UNITED STATES PATENT AND TRADEMARK OFFICE

10/777,496

Office Action Summary	Application No. 10/777,496	Applicant(s) ANDREWS ET AL.	
	Examiner AMY T. LANG	Art Unit 3731

DETAILED ACTION

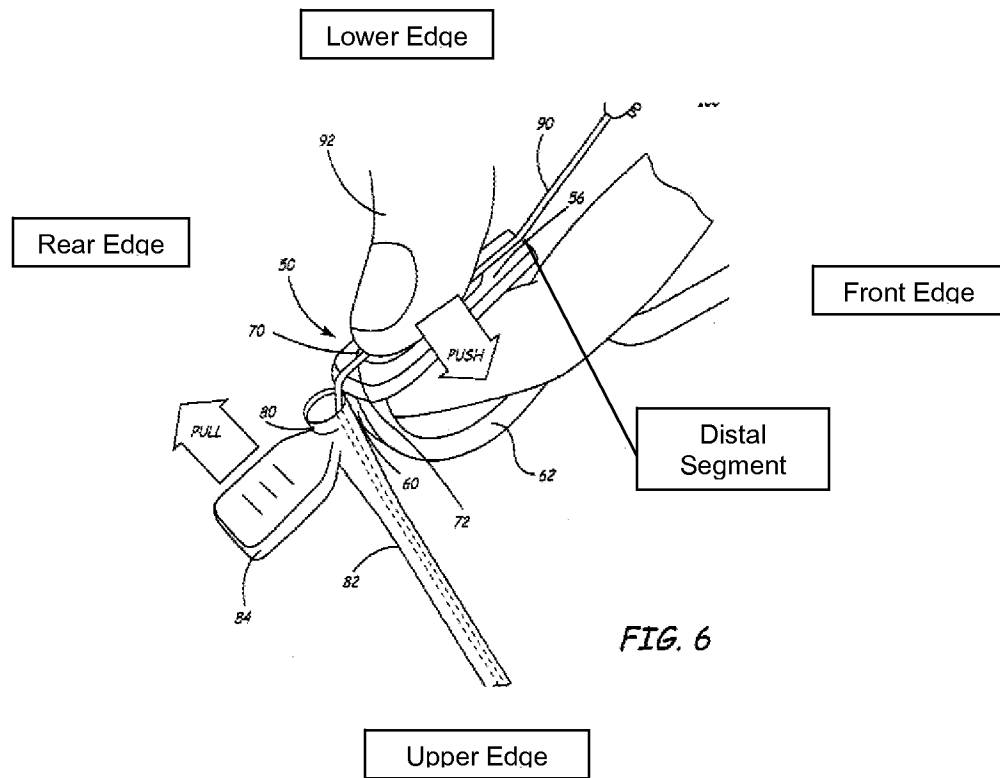
With regard to **claims 1 and 9**, Gardeski et al. (hereinafter Gardeski) discloses a device for removing a guide catheter from a linear lead (see entire document). The device comprises a body (62) having a front, rear, upper, and lower edge. The edge sides are all relative placement terms such that the upward side, as shown in the figures, can be deemed a lower edge. Furthermore, the device is configured for use in an upward down placement which would cause the lower and upper edge to be as such shown below.

As shown in Figure 4 and below, Gardeski discloses a distal lead management segment (51) having an outer surface and comprising a side opening member, the rear or front opening ([0050]). The lumen through the side opening (72) overlaps the instantly claimed central opening since it is sized to engage the linear lead. The distal lead management segment is adjacent the lower edge and positioned between the front and rear edges of the body. Additionally, the device of Gardeski only secures the linear

**FIG. 3**

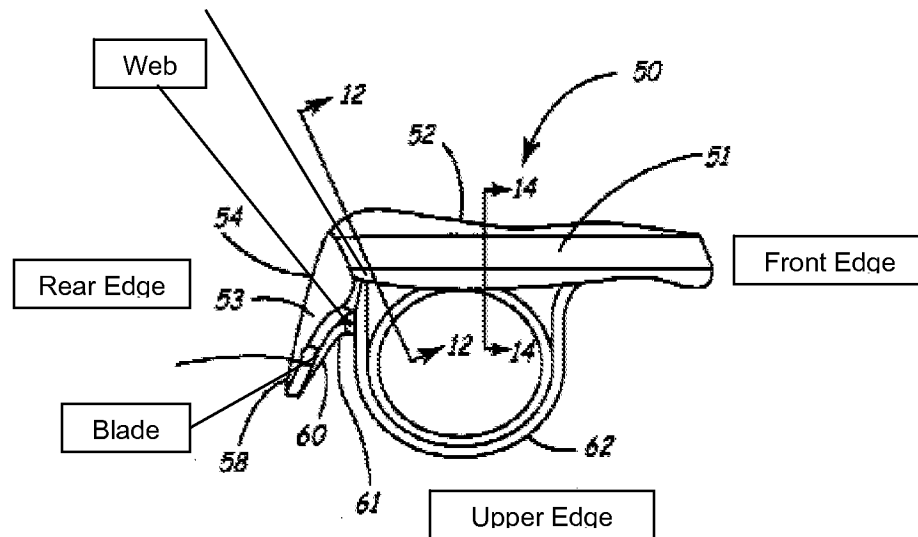
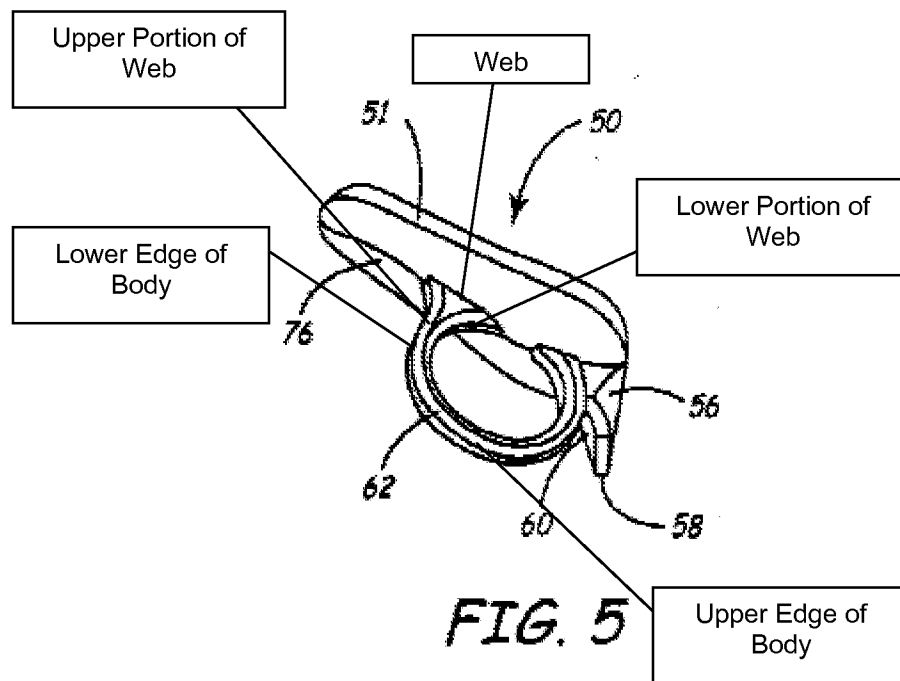
A blade (60) is mounted on the distal lead management segment (51) and connected to the body (62) by a connecting segment located between the lower edge and the distal segment (column 7, line 61 through column 8, line 10). As shown in Figure 3 and below, the distal lead management segment comprises a rear portion (53) that extends distal of the blade and overlaps the instantly claimed outer surface. Therefore, the blade is then mounted between the lower edge and this outer surface.

The blade is further disclosed as having a sawtooth configuration, which clearly overlaps the first and second cutting portions ([0045]). Further, a notch would be present between each cutting portion.

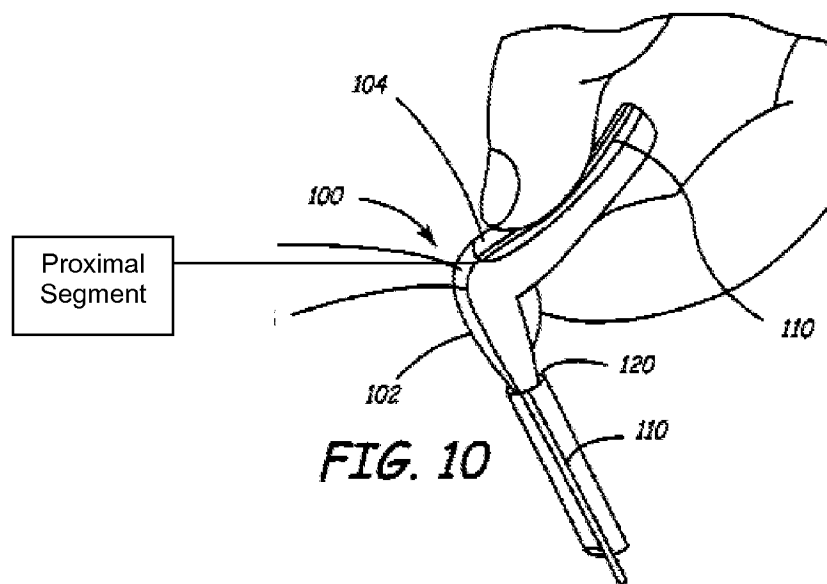
With regard to **claim 2**, since the cutting blade (60) is positioned close to the distal lead management segment and comprises the notch, it is the examiner's position that the notch is proximate the distal segment (Figure 3).

**FIG. 3**

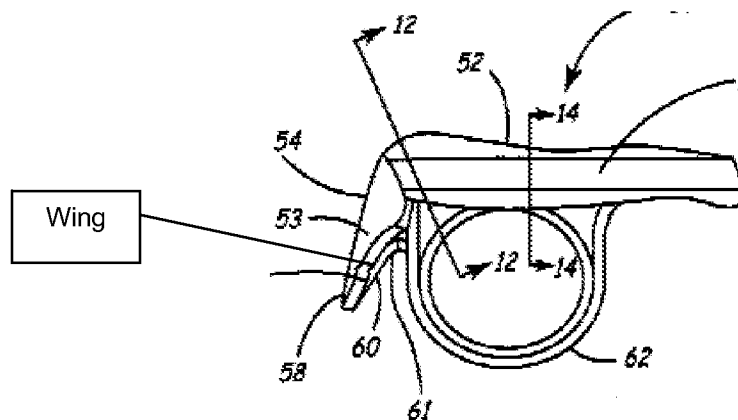
With regard to **claims 6 and 11**, Gardeski, discloses laterally opposing wings. One wing, as shown below, comprises the distal tip portion of nose (53) with the other wing being the equivalent on the other side of the device. Each wing is angled downward and is rearward of the blade.
